V8 XJ Series/XK

413-S484

TECHNICAL BULLETIN

Instrument Pack Assembly – CAN Failure – Service Action S484

ILLUSTRATION 2

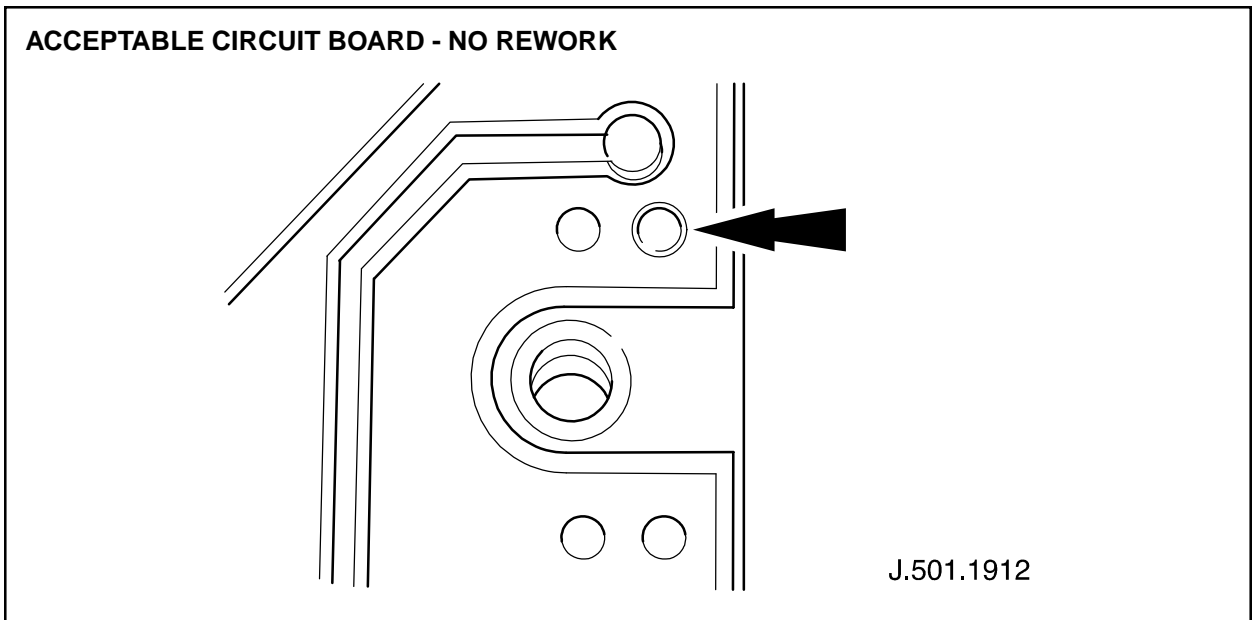
Illustration 2 shows an acceptable circuit board. This board does not require rework.

ILLUSTRATION 3

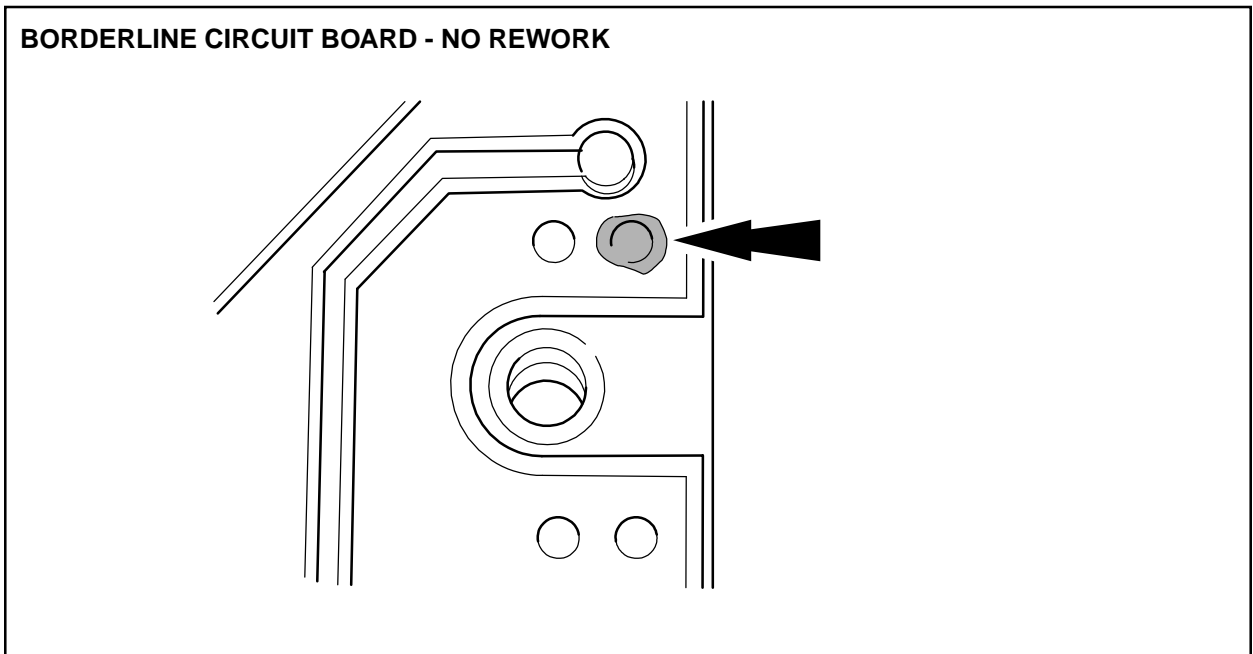
Illustration 3 shows a borderline case. This circuit board does not require rework.

ILLUSTRATION 4

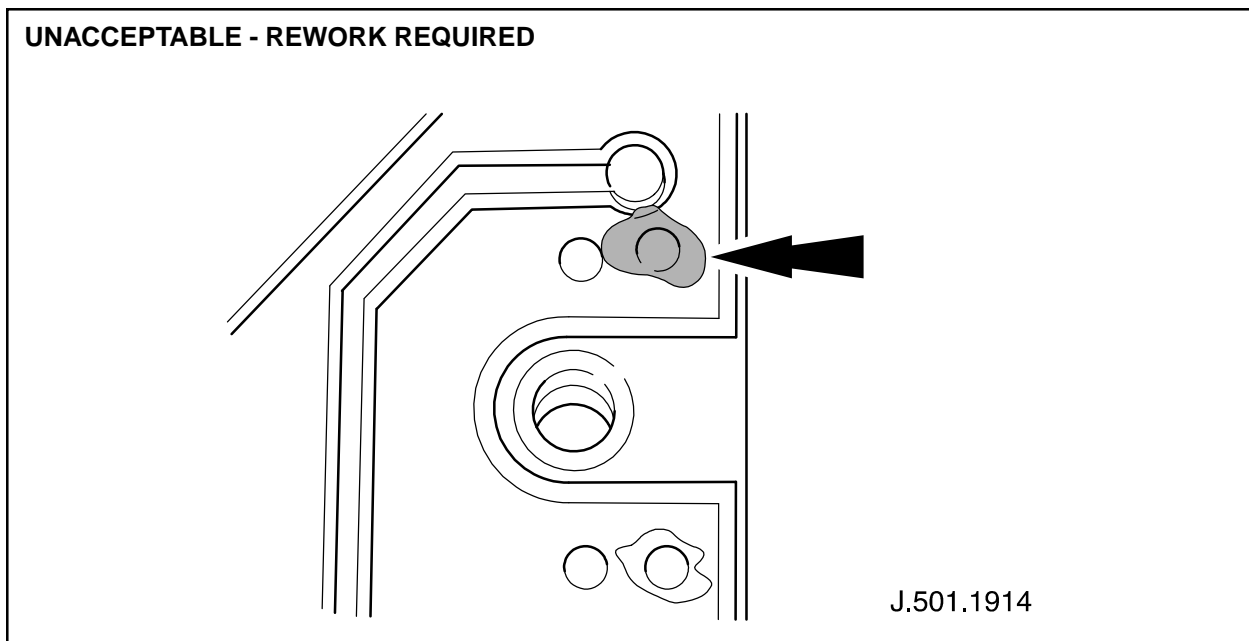
Illustration 4 shows an unacceptable case. This circuit board requires rework

If rework of the solder area is required (Illustration 4) proceed to step 11.

ILLUSTRATION 5

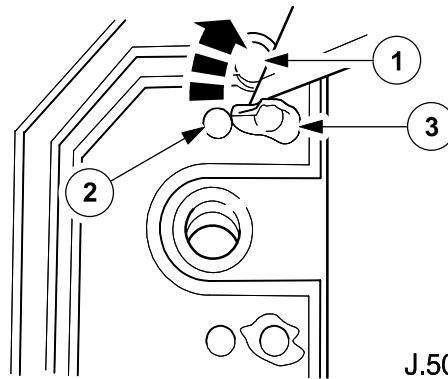
⚠ Caution: Do not use the craft knife in a downward cutting action across the board. This will damage the board. Cut at an angle ensuring that only the solder is cut through. Ensure all traces of cut solder are removed and discarded. Do not leave any solder particles. This could cause further contamination to the board. Do not remove solder from other areas of the circuit board, only those identified in this Service Action.

11. Using a sharp craft knife, raise and fold back any solder that has spread beyond the borderline area, as shown in illustration 5
12. Using a sharp craft knife, cut off the raised solder segments. See illustration 5.
13. Using a continuity meter, check there are no shorts between test point 1 and the two adjacent solder points 2 and 3 as shown in Illustration 5.

Note: Do not test between points 2 and 3 since these are ground points.

⚠ Caution: During the test operation in step 13, if a short is present, repeat solder removal operation.

ILLUSTRATION 6

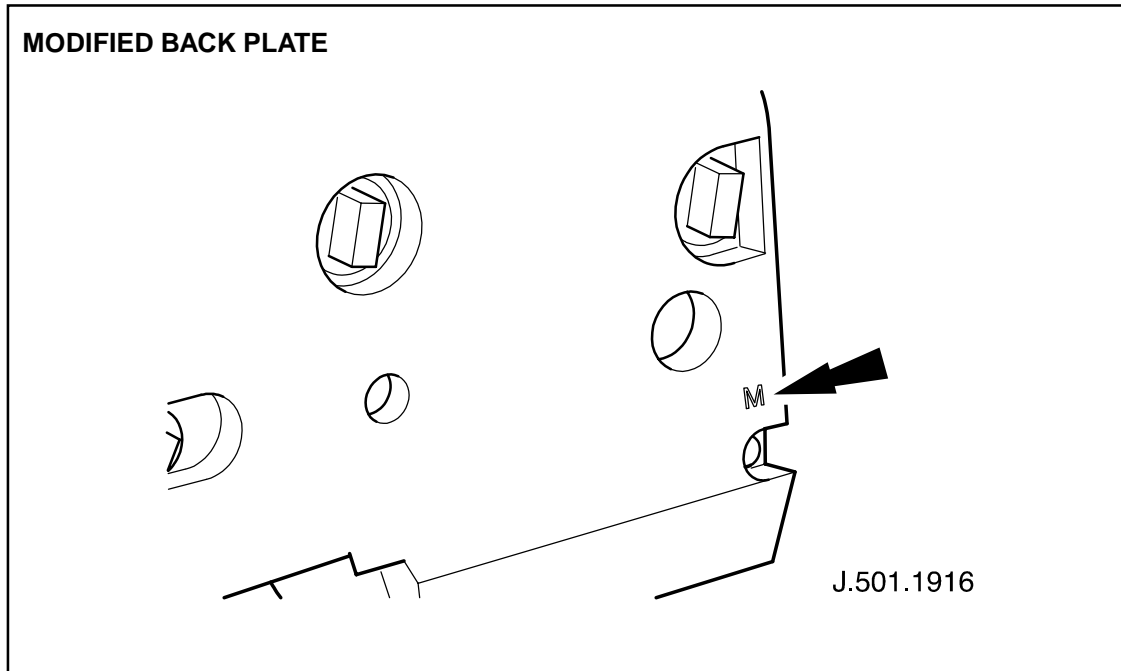
14. Position and seat the new supplied module back plate. (Modified back plate has relieved screw boss).

Note: The supplied modified back plate is identified by an “M” mark on the outer face, this will inform future workshops that the back plate has been replaced (Illustration 6).
